Department of Public Works  
**Engineering Division**  
Robert F. Phillips, P.E., City Engineer  
City-County Building, Room 115  
210 Martin Luther King, Jr. Boulevard  
Madison, Wisconsin 53703  
Phone: (608) 266-4751  
Fax: (608) 264-9275  
[engineering@cityofmadison.com](mailto:engineering@cityofmadison.com)  
[www.cityofmadison.com/engineering](http://www.cityofmadison.com/engineering)

NOTICE OF ADDENDUM  
ADDENDUM NO. 2  
CONTRACT NO. 8498  
ROCKSTREAM DRIVE ASSESSMENT DISTRICT – 2020

12694  
 X-6

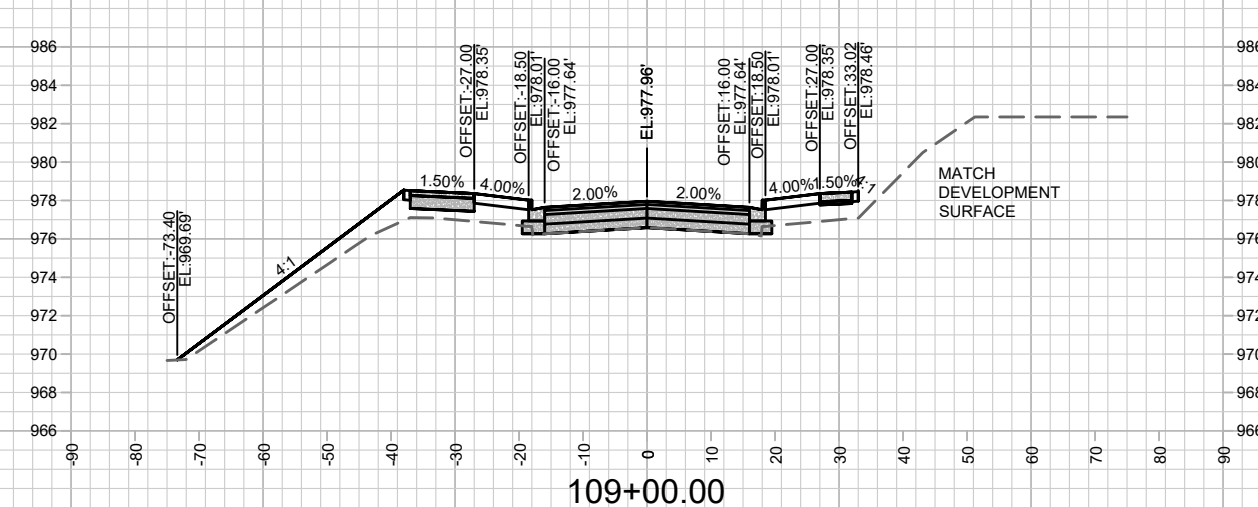
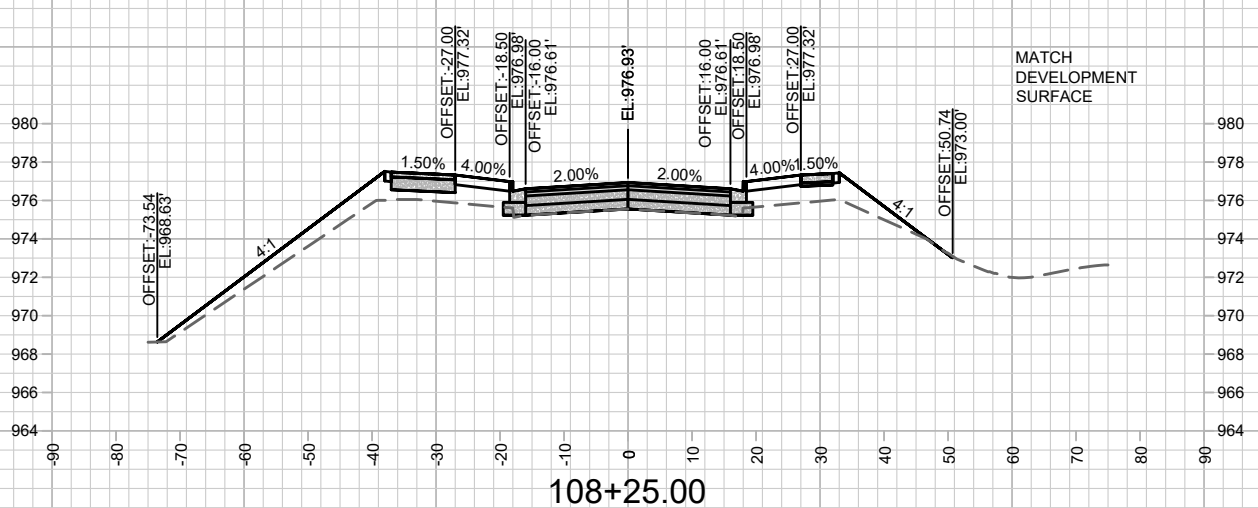
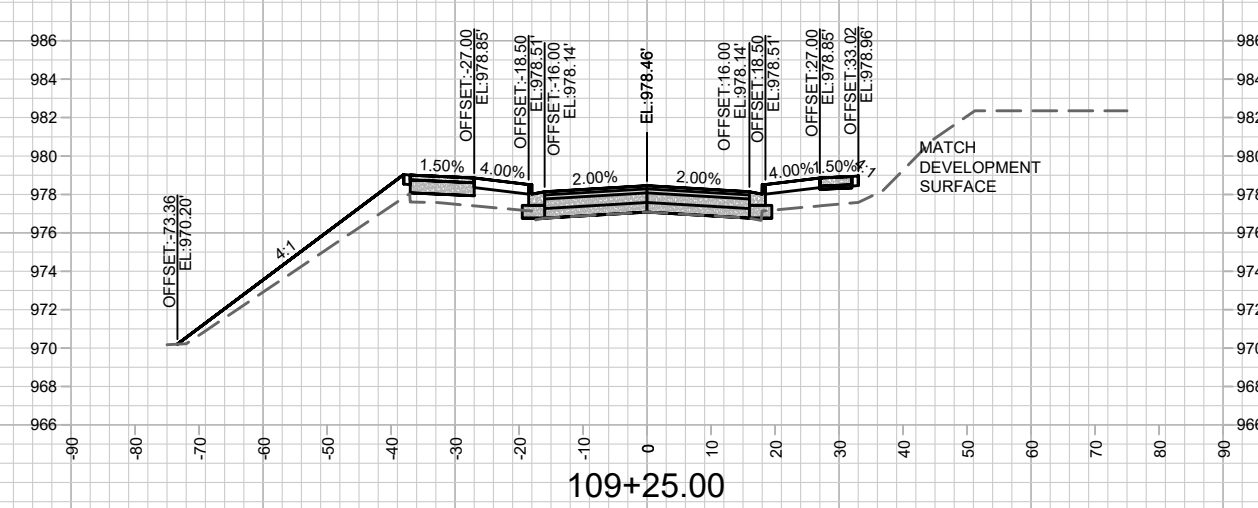
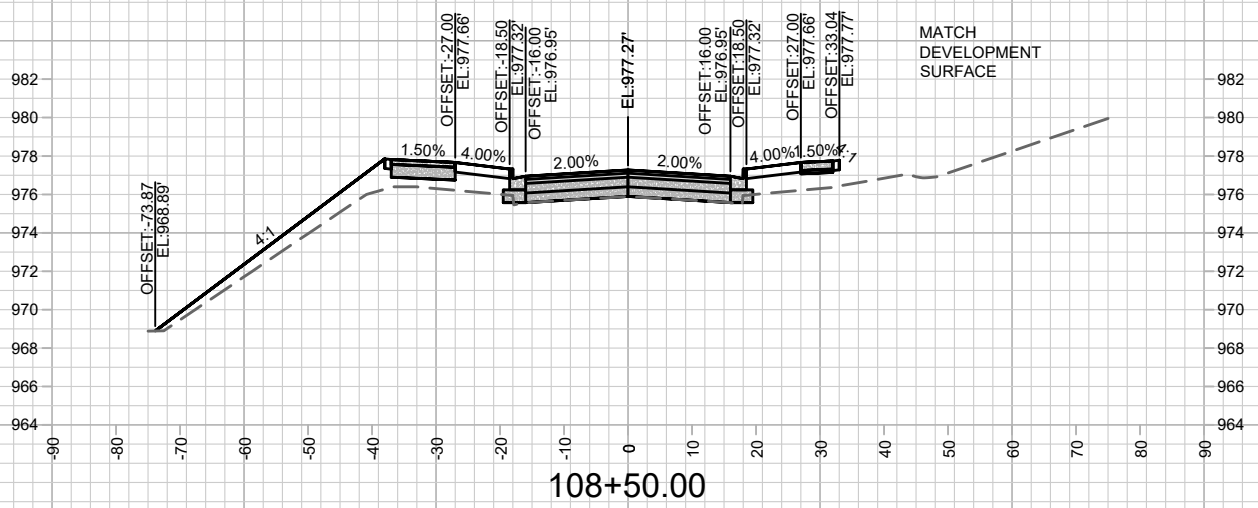
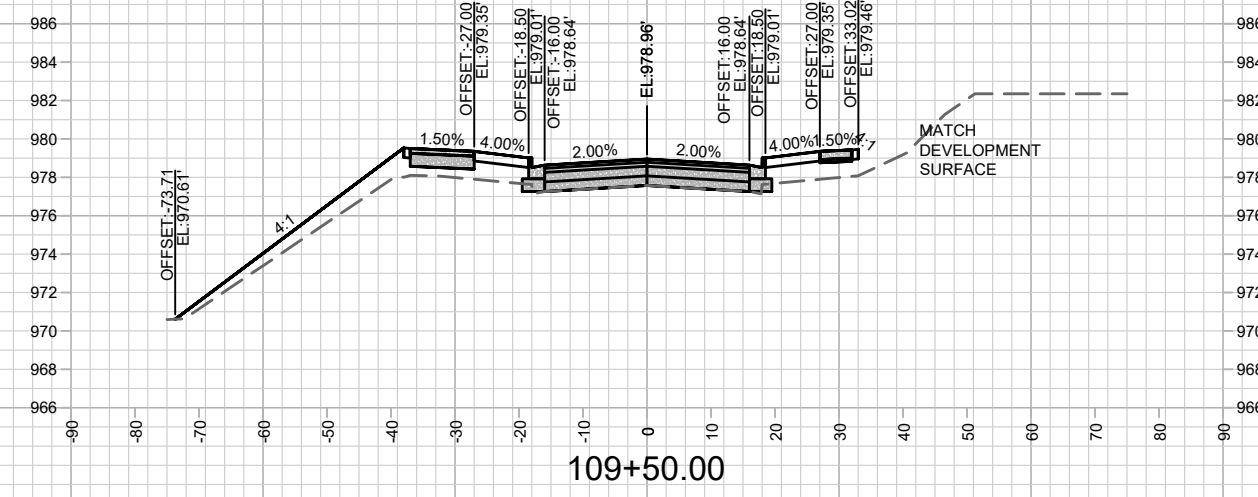
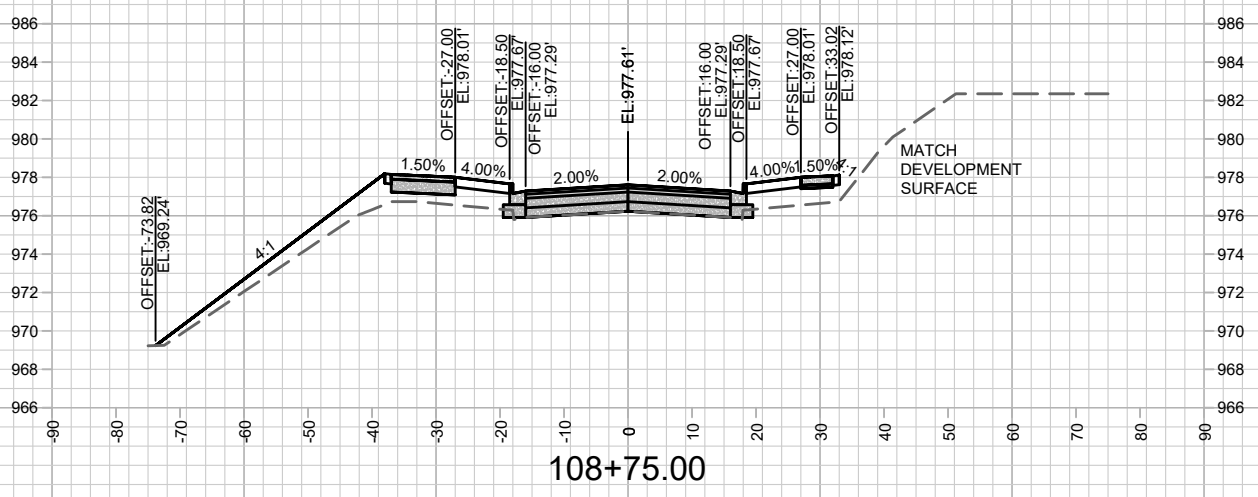
X-5 – X17: Update existing surface to reflect current site conditions.

11-30-2020 REVISION AJZ  
 - Updated Existing Surface

12694  
 X-10

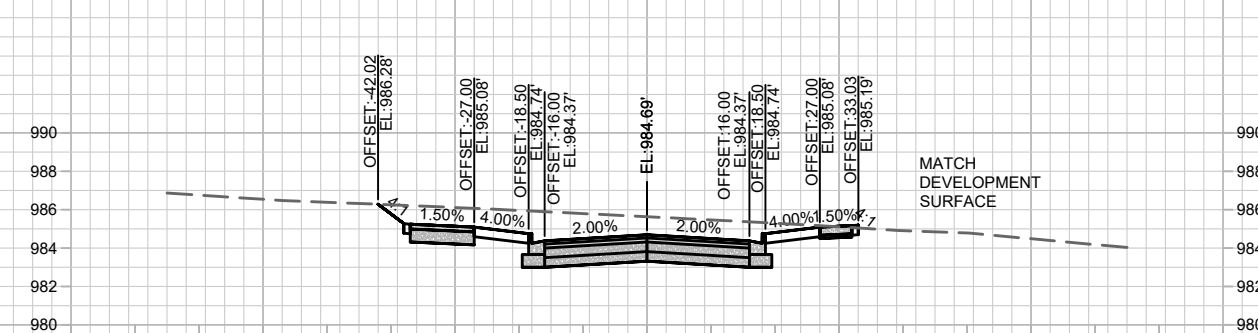
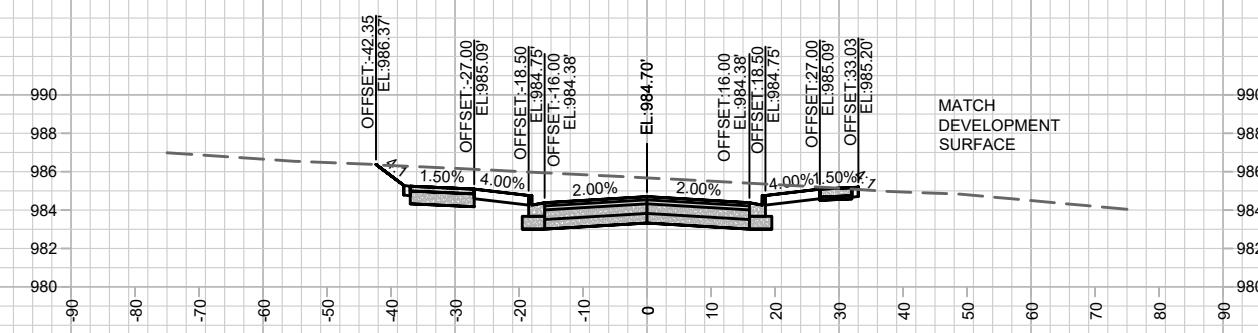
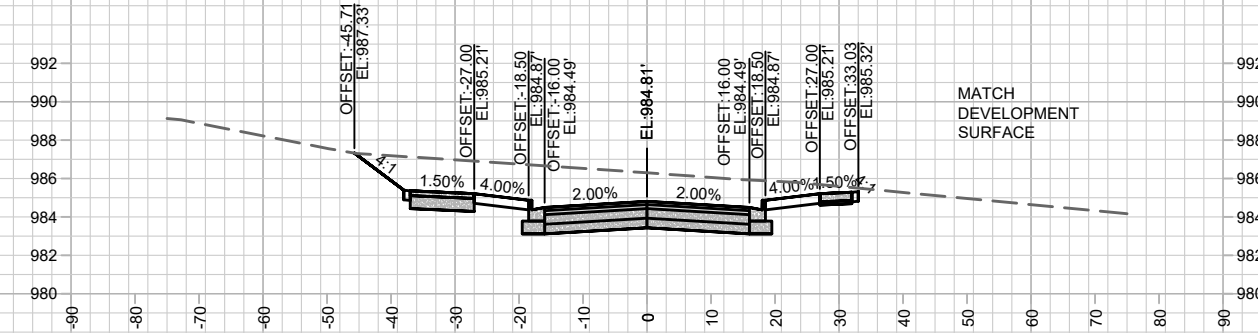
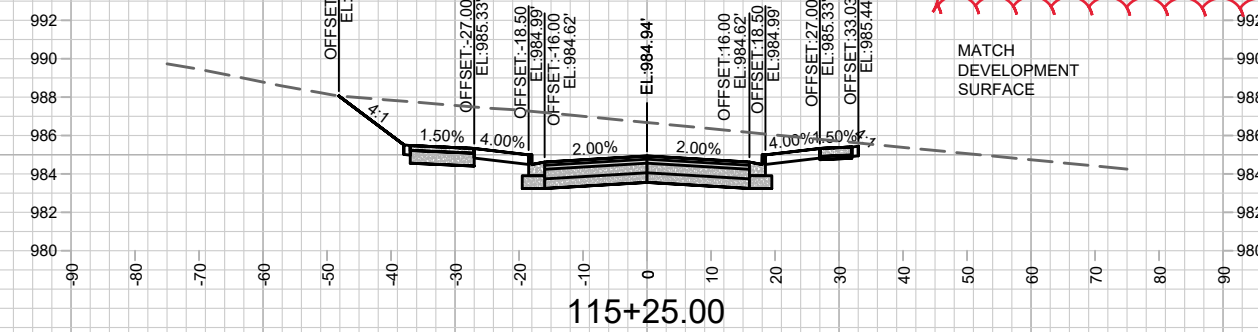
11-30-2020 REVISION AJZ  
- Updated Existing Surface

BY: X-14

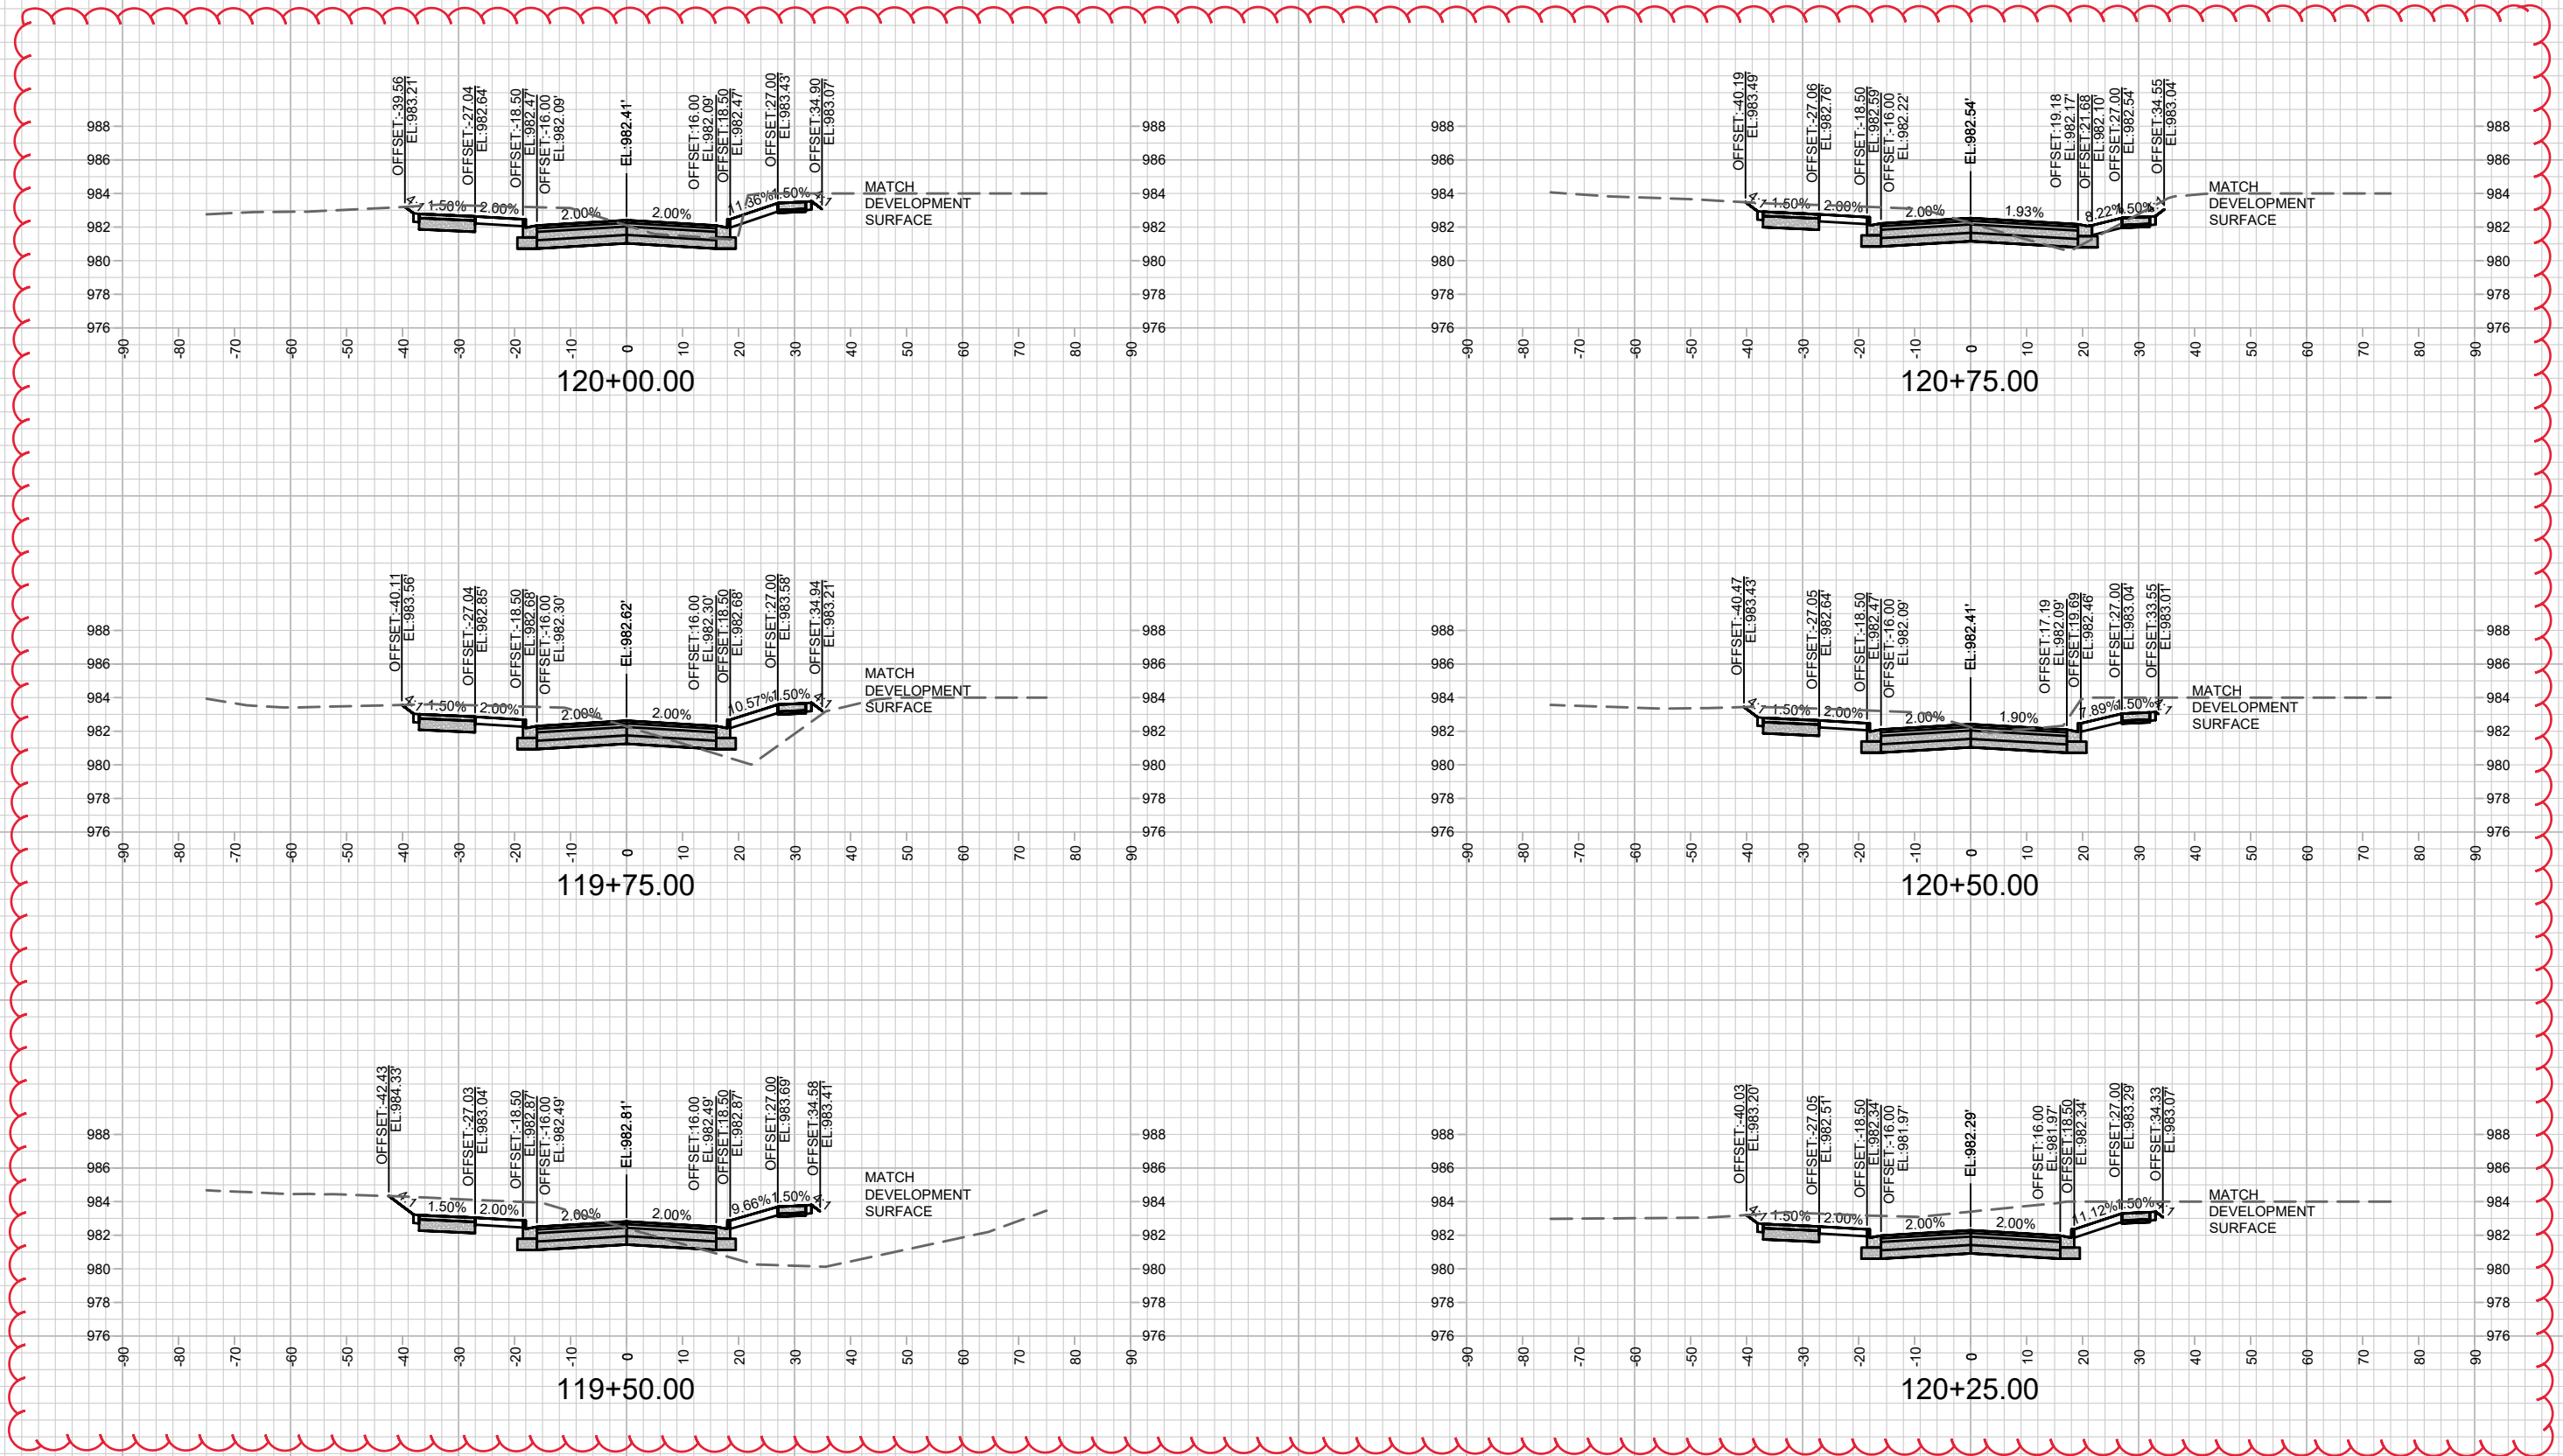
11-30-2020 REVISION AJZ  
 - Updated Existing Surface
